寄件者: Chan Richie [REDACTED]
寄件日期: 2026年09月23日星期三 8:55
收件者: Esther Hiu Laam LI/PLAND
副本: Yicko
主旨: SUBMISSION OF INTEGRATED TECHNICAL COMPLIANCE REPORT AND APPENDIX INDEX FOR APPLICATION NO. A/NE-LYT/826 & 881
附件: FIRE SERVICE CERTIFICATE 2026 P2.jpg; FIRE SERVICE CERTIFICATE 2026 P1.jpg; Appendix A (排水01 03092026).pdf; Appendix B (水渠01 03092026 Drainage Proposal.pdf; Appendix C (平面圖01 03092026).pdf; Appendix E (指示牌及地上方向路線 01).pdf; LYT826 Compliance Letter for Conditions 排水 Signed.pdf; LYT826 Compliance Letter for Conditions 消防 Signed.pdf; Appendix D (車流量 動線圖01 03092026) P6.pdf; Appendix D (車流量 動線圖01 03092026) P5.pdf; Appendix D (車流量 動線圖01 03092026) P4.pdf; Appendix D (車流量 動線圖01 03092026) P1-3.pdf
類別: Internet Email

**Proposed Temporary Private Vehicle Park (Private Cars Only)
for a Period of 3 Years in “Residential (Group C)” Zone,
Lots 807 S.E, 827 RP (Part) and 828 RP in D.D. 83, Lung Yeuk Tau, Fanling
Submission for Compliance with Approval Condition (a)
Submission of Revised Drainage Proposal**

SUBMISSION REPORT
FOR
DRAINAGE PROPOSAL DESIGN
FOR TEMPORARY PRIVATE VEHICLE PARK (PRIVATE CARS ONLY)
FOR A PERIOD OF 3 YEARS
LOT 807 S.E, 827 RP (PART) AND 828 RP IN D.D.83
LUNG YEUK

1 Plan: Swept Path
001 SCALE = 1:200

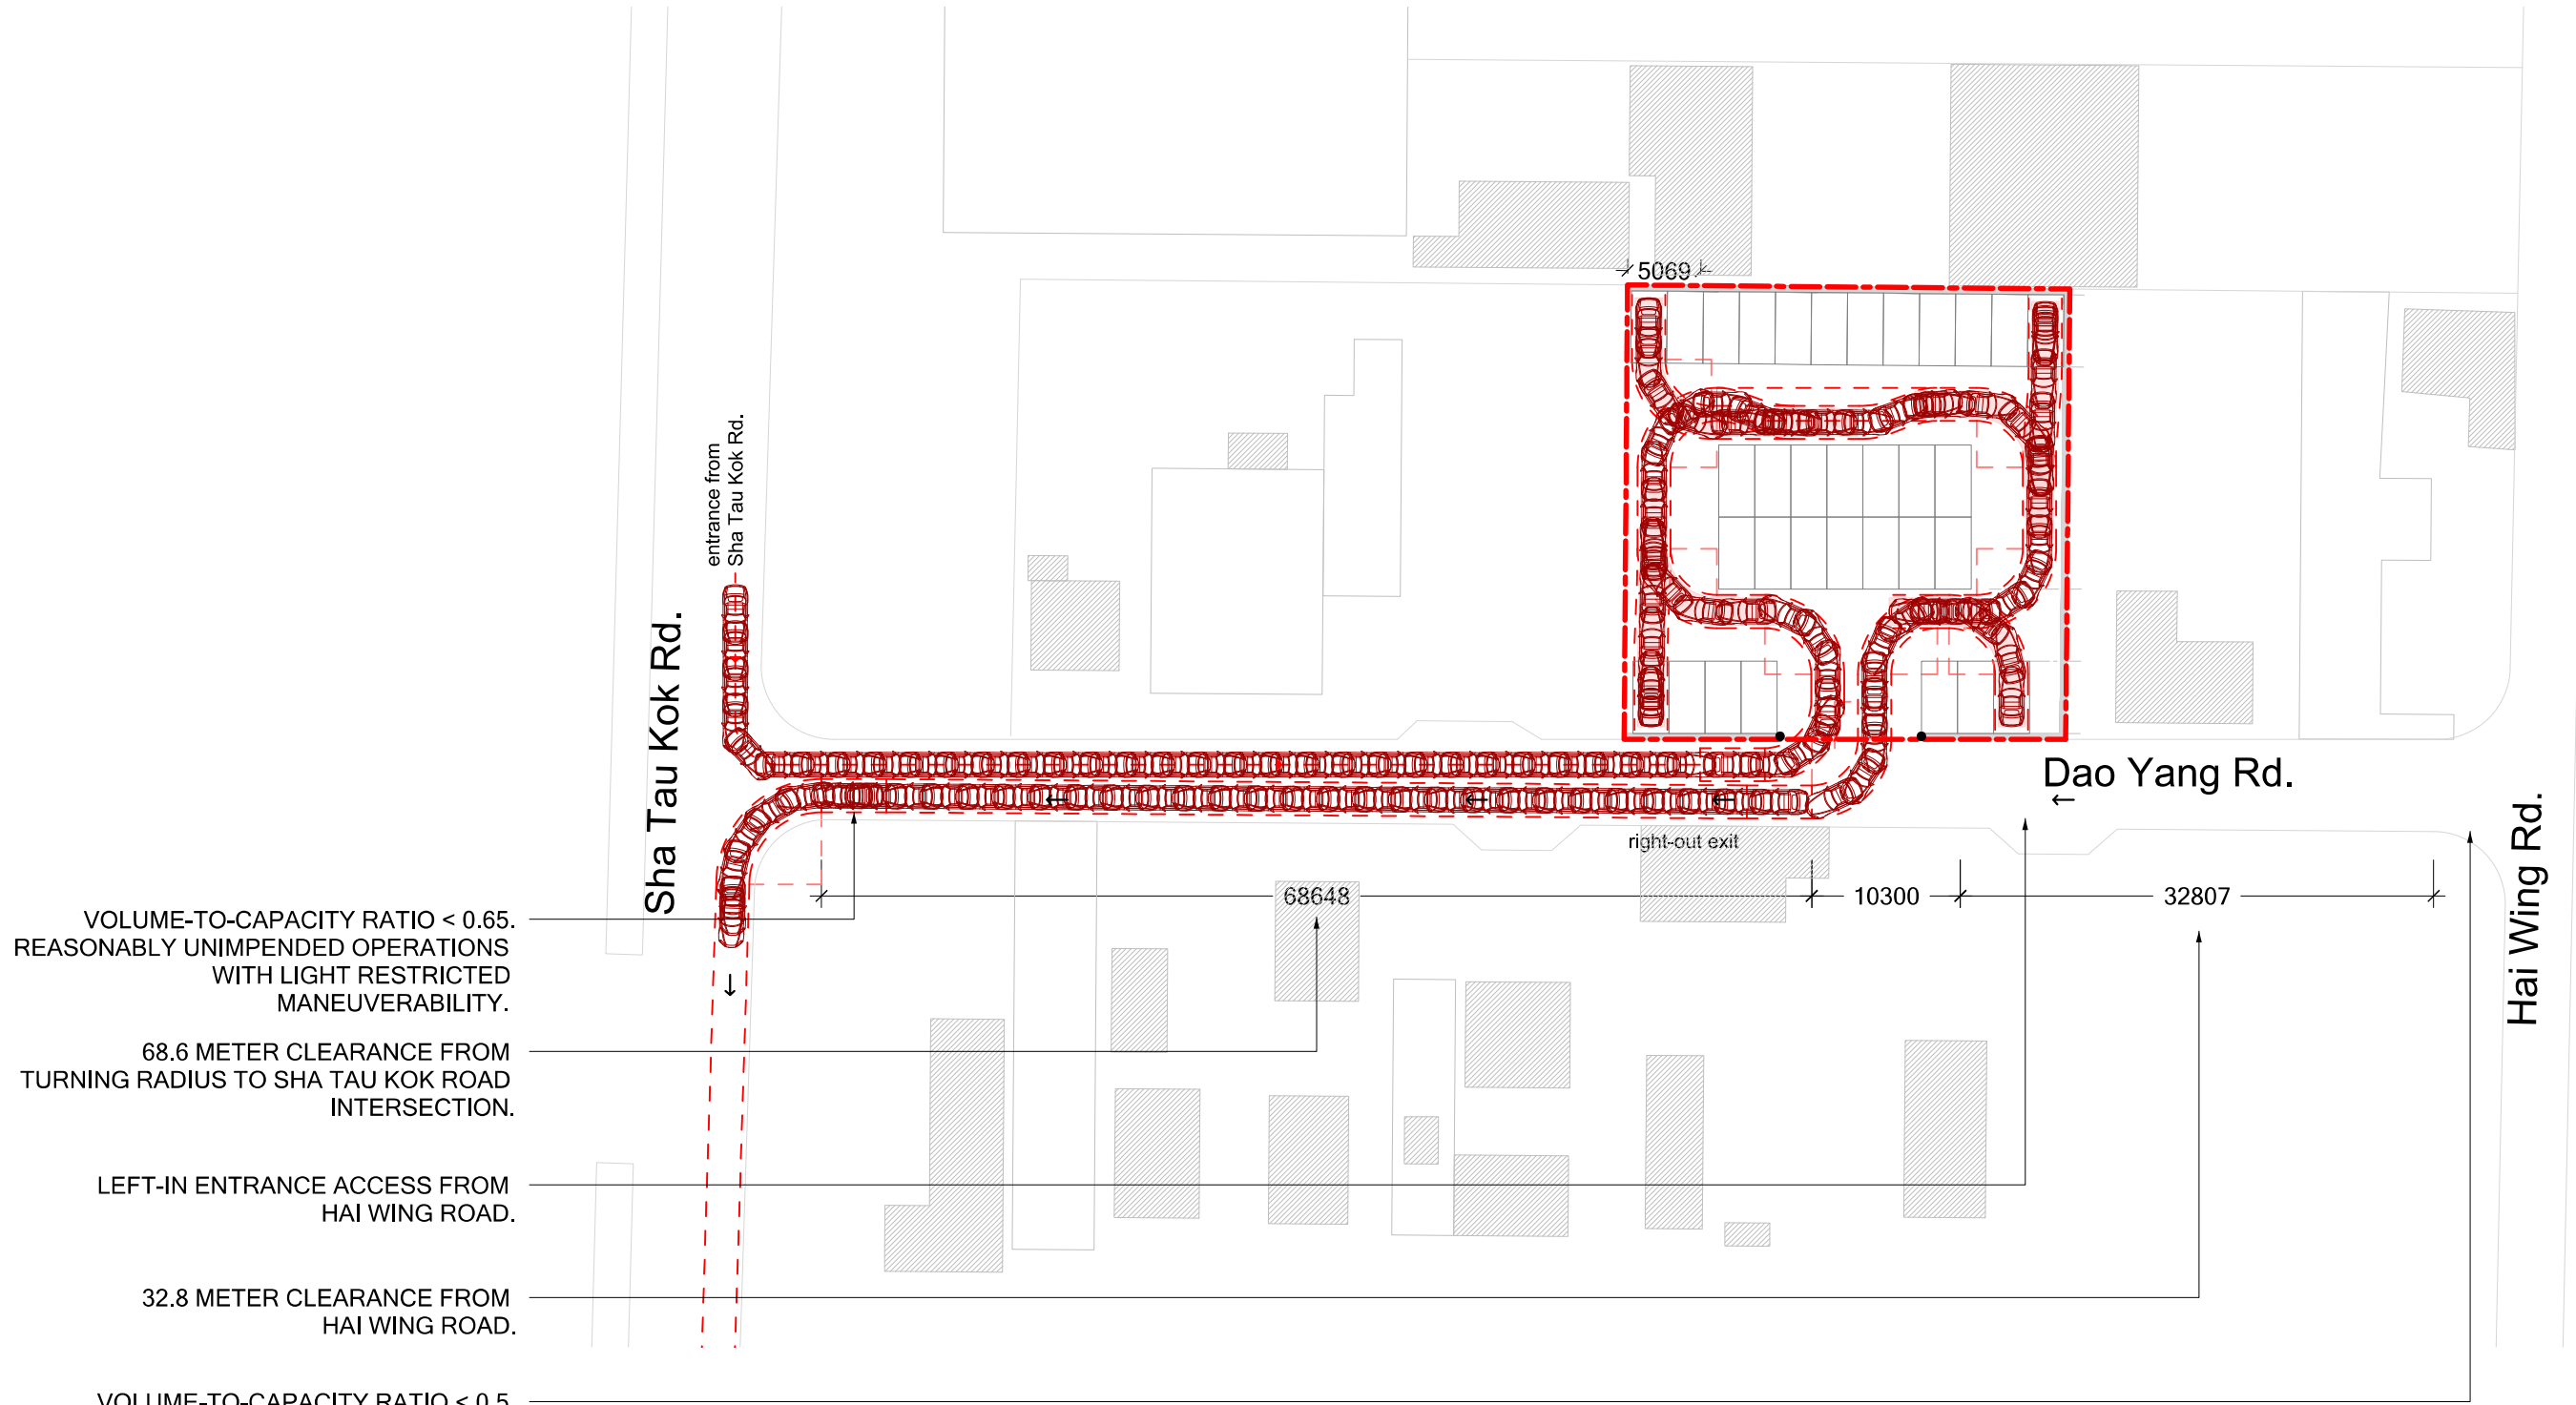
3. In the latest swept path analysis diagrams provided by the applicant, only the discrete positions of the vehicle were shown. Continuous profile of the outline of the vehicle should be shown along the whole path of travelling.
